11869A RF PLUG-IN ADAPTER

MANUAL PART NO. 11869-90006
Microfiche Part No. 11869-90007

SECTION VII
MANUAL BACKDATING CHANGES

Figure 7-8. P/O A2 Connector Board Schematic (CHANGE D)

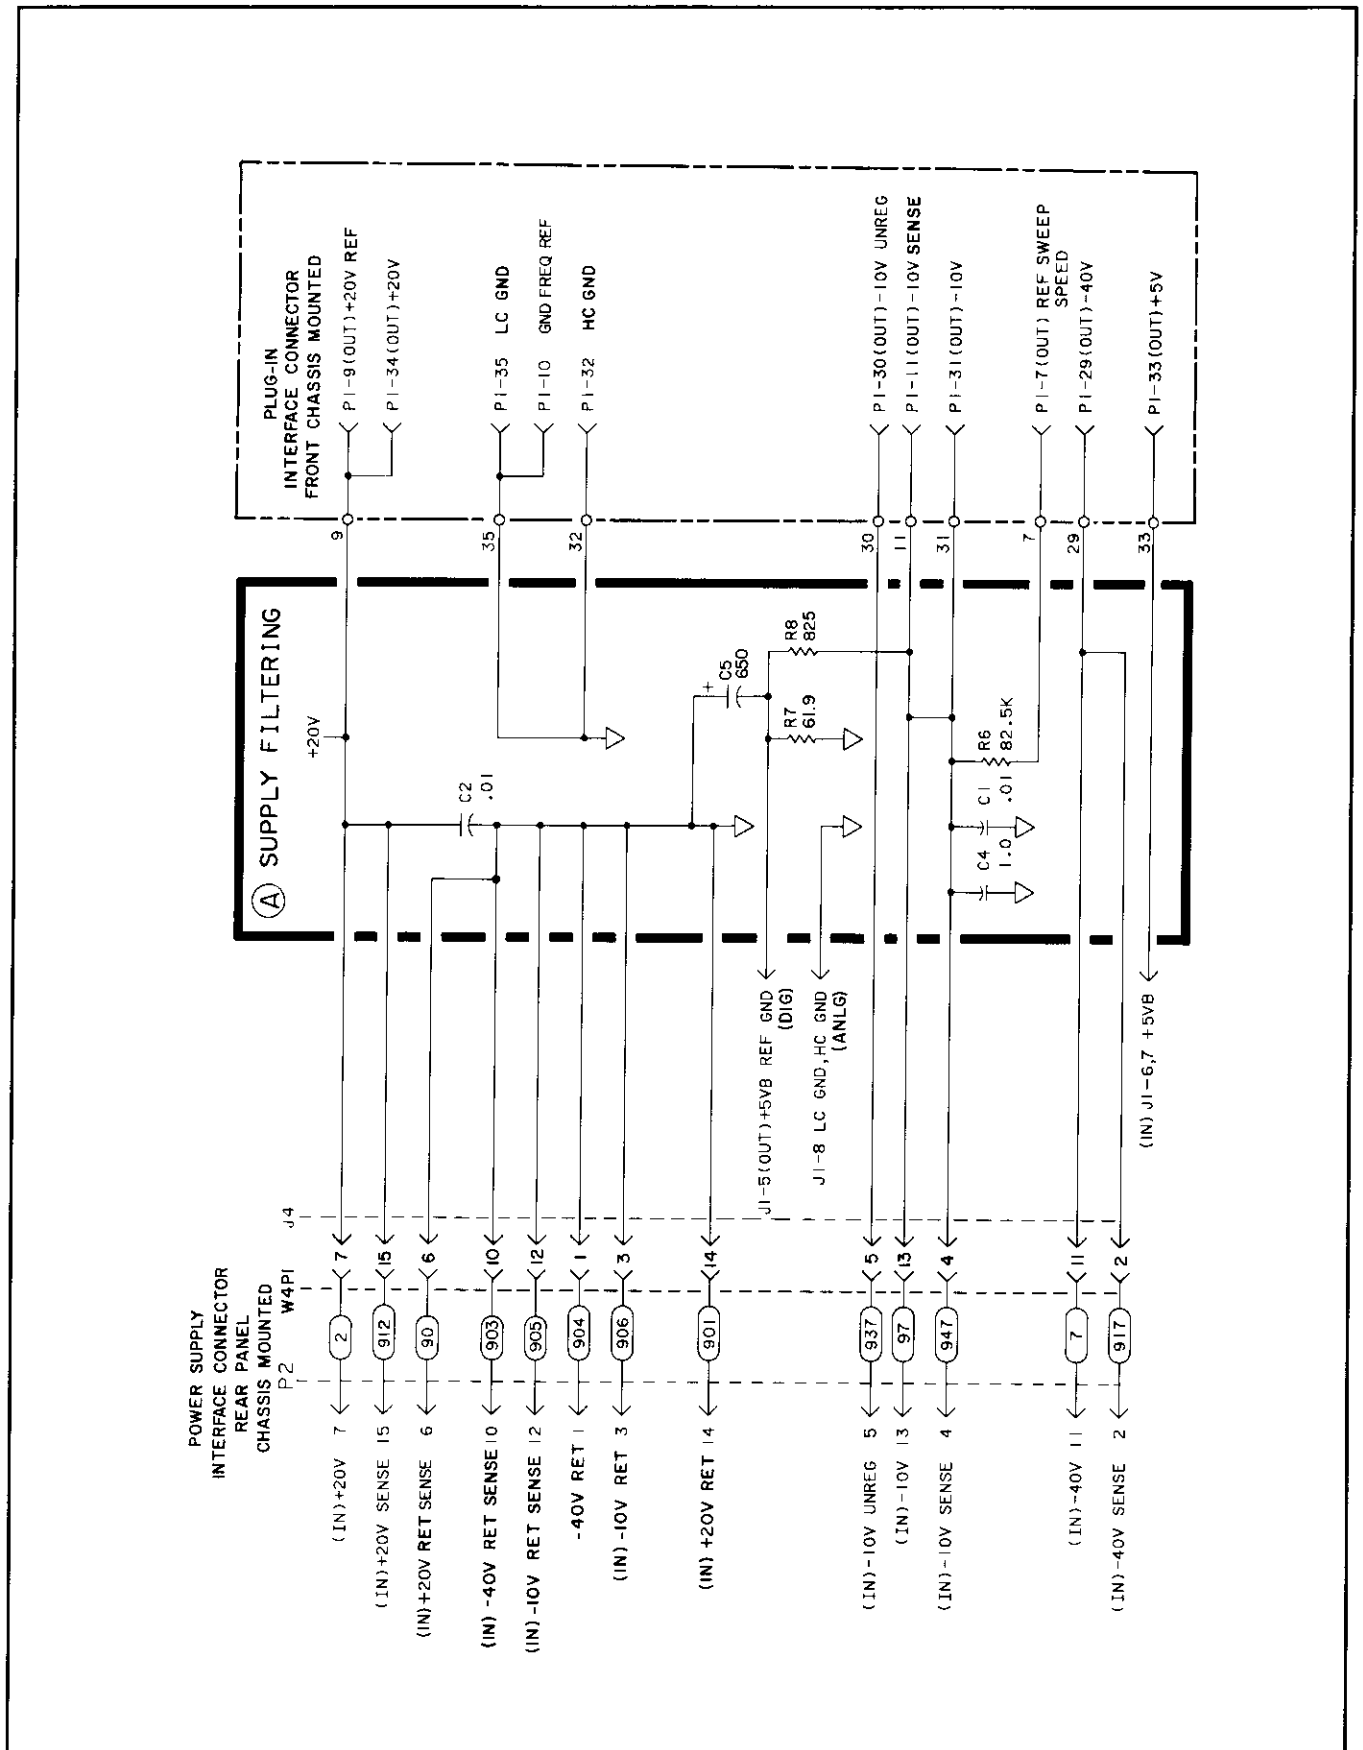
Page 8-21, Figure 8-9:

Change A2 to HP Part Number 11869-60011.

Change the A2 Connector Board Schematic according to the partial schematic **P/O A2 Connector Board Schematic (CHANGE D)** in this section.

Figure 7-9. Cable Interconnect Schematic (CHANGE D)

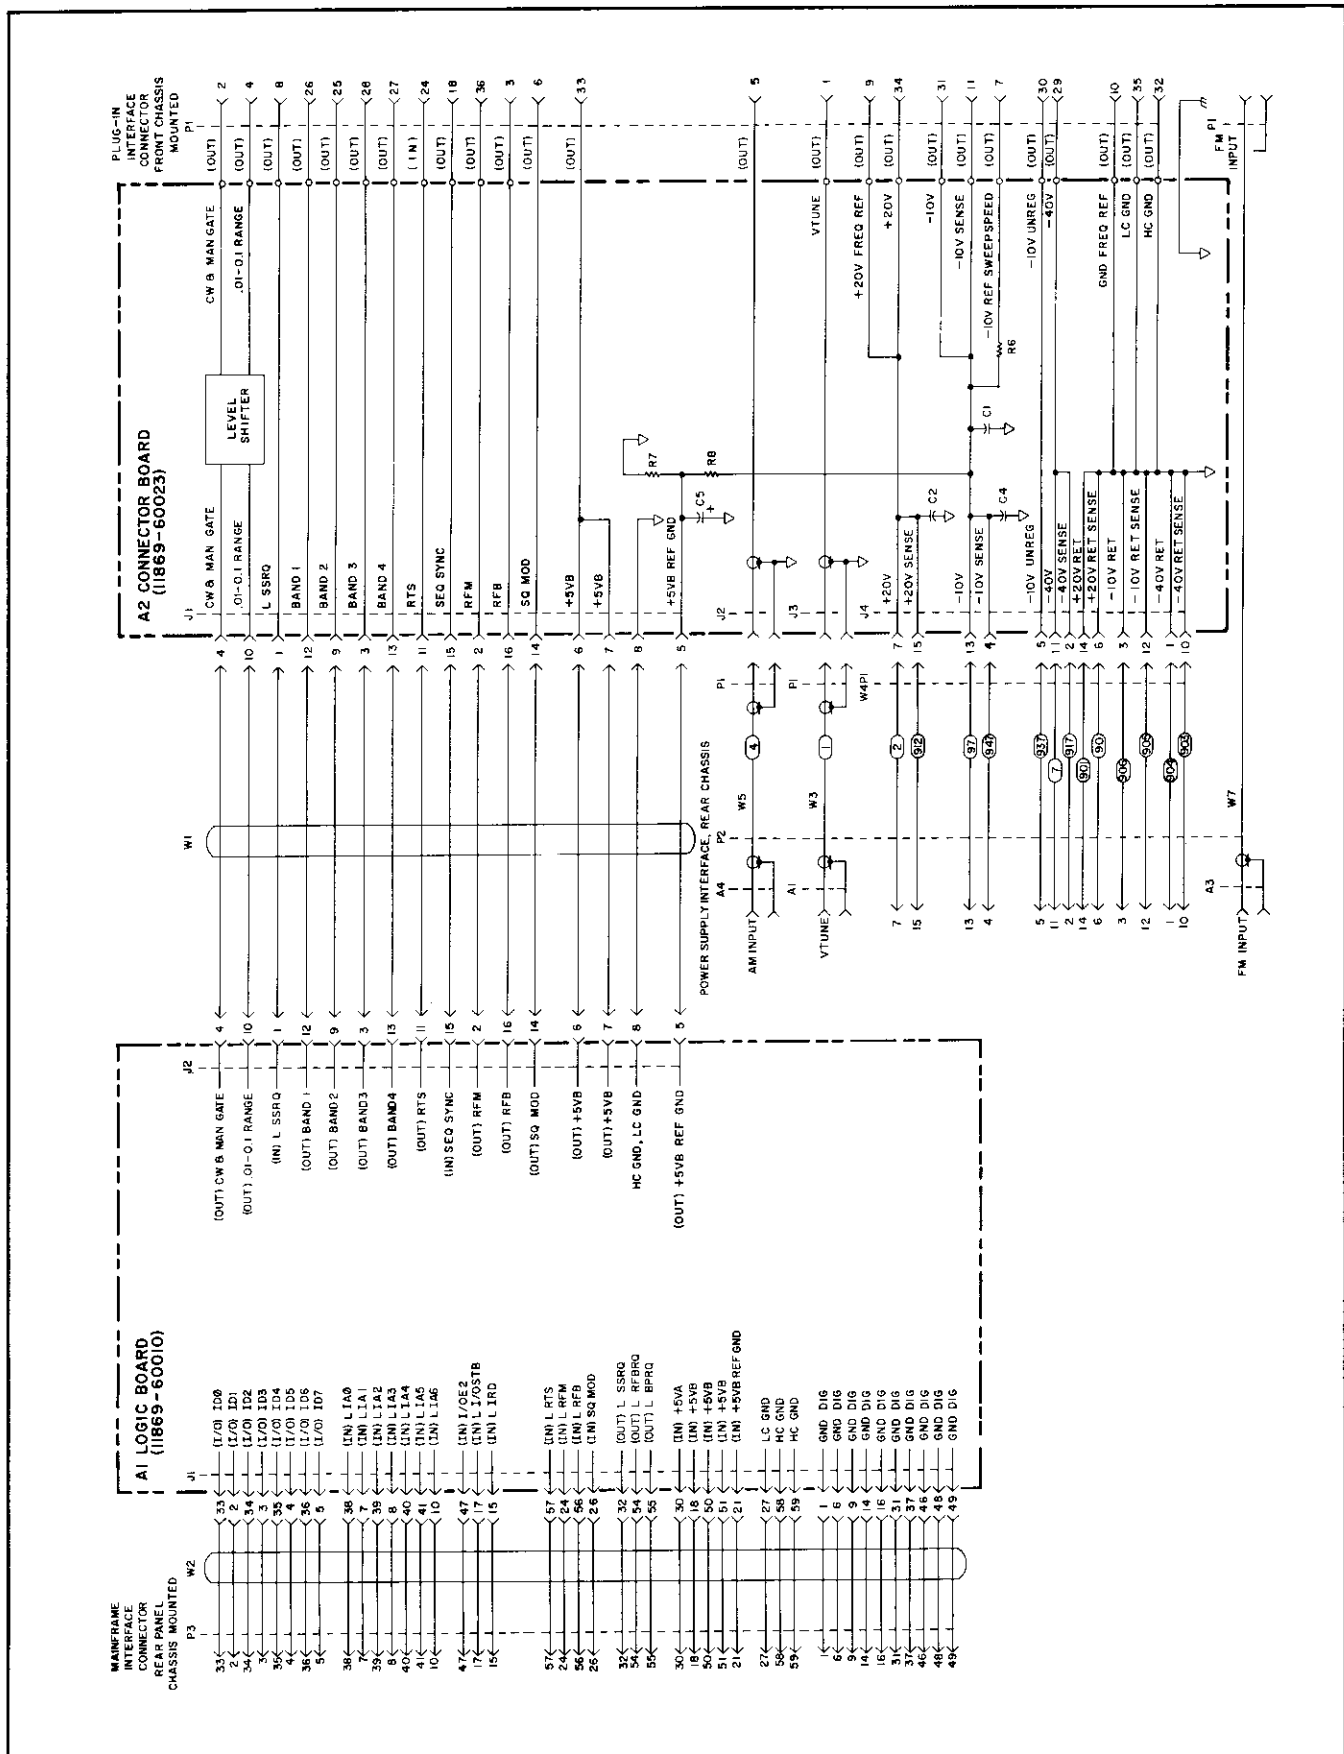
Page 8-23, Figure 8-10:

Replace Figure 8-10 with the **Cable Interconnect Schematic (CHANGE D)** in this section.
